Plant: Nine Mile Point Unit 1  
Date of Event: 9/6/2017  
Submittal Date: \_\_\_\_\_  
Licensee Contact: Rose Demko Tel/Email: rose.demko@exeloncorp.com  
NRC Contact: Eric Miller Tel/Email: eric.miller@nrc.gov

Unplanned Scrams with Complications

NMP1 Scram 9/6/17 Lo Reactor Water Level

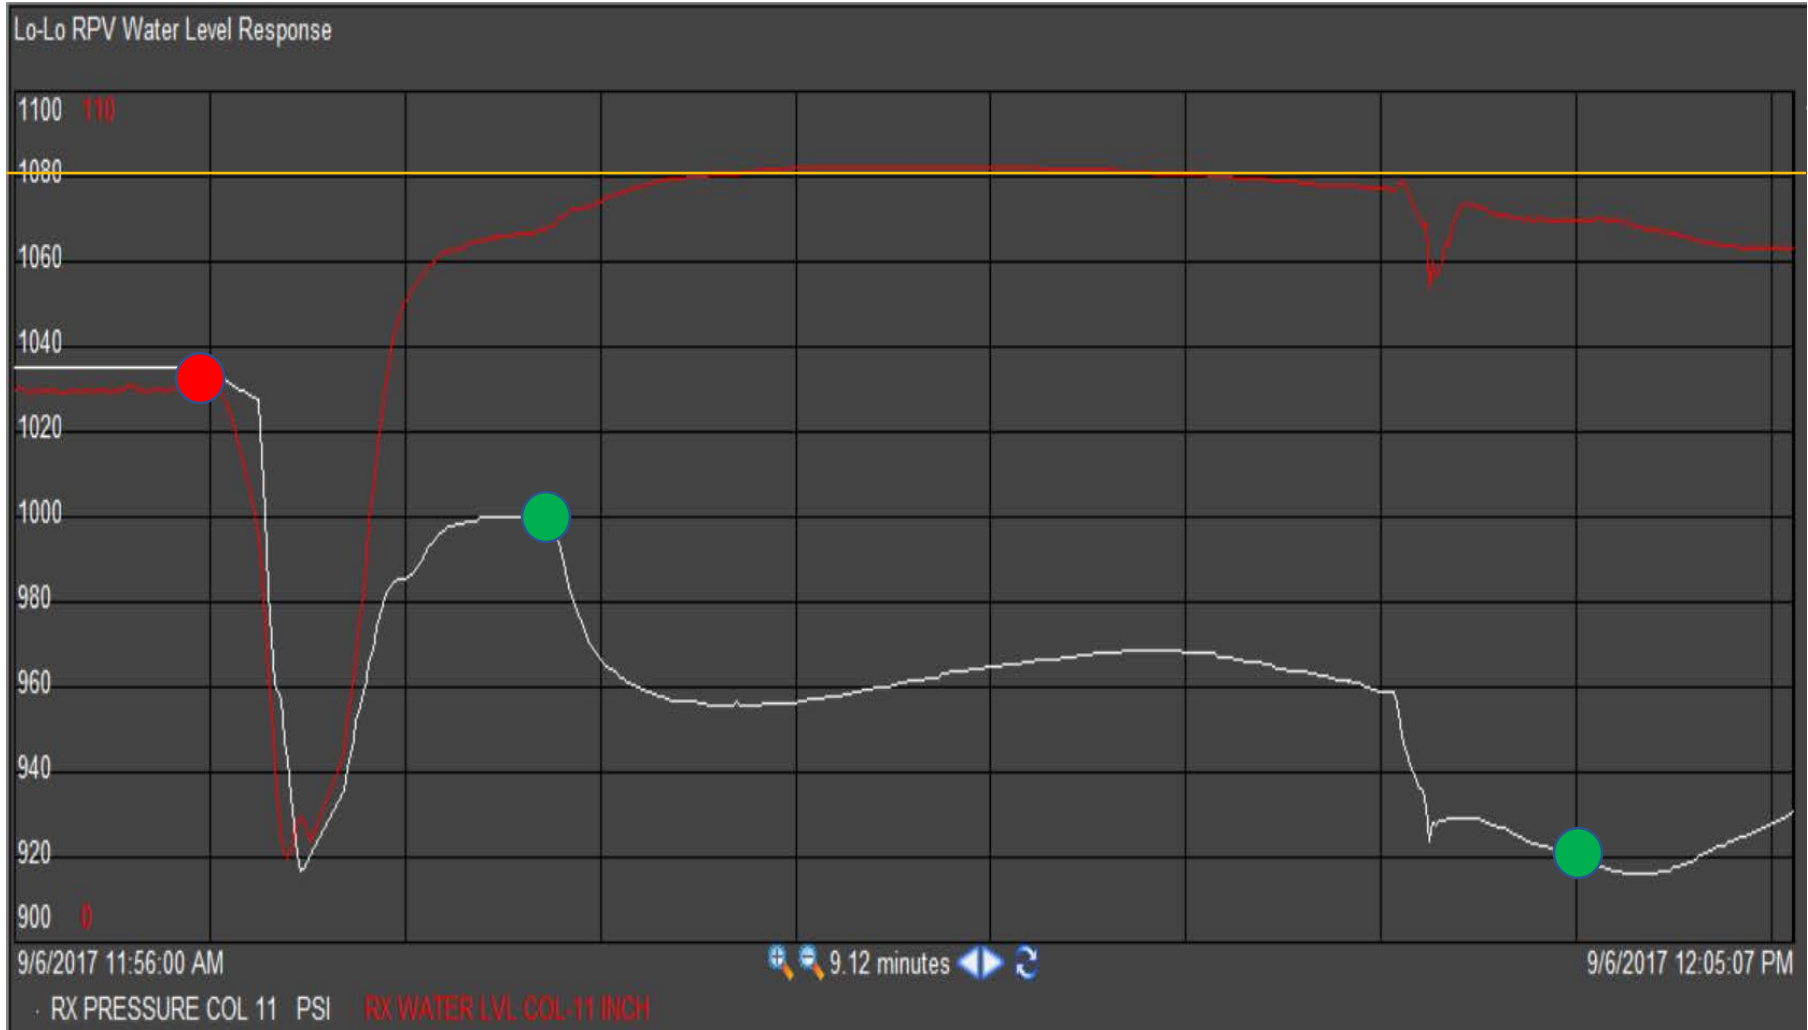
The initial Lo RPV Water Level, post scram, was the only EOP entry condition setpoint met during or after the transient. The Lo RPV water level recovered to within normal operating band without Operator Actions as expected. No reactor or drywell pressure EOP entry conditions occurred during or after the transient. The highest pressure in the reactor during the transient

was 1005 psig, well below the EOP entry condition of 1080 psig. No conditions or equipment issues existed during the duration of the scram response requiring re-entry or extended operation in the EOP. Therefore, the answer to this statement is "No."
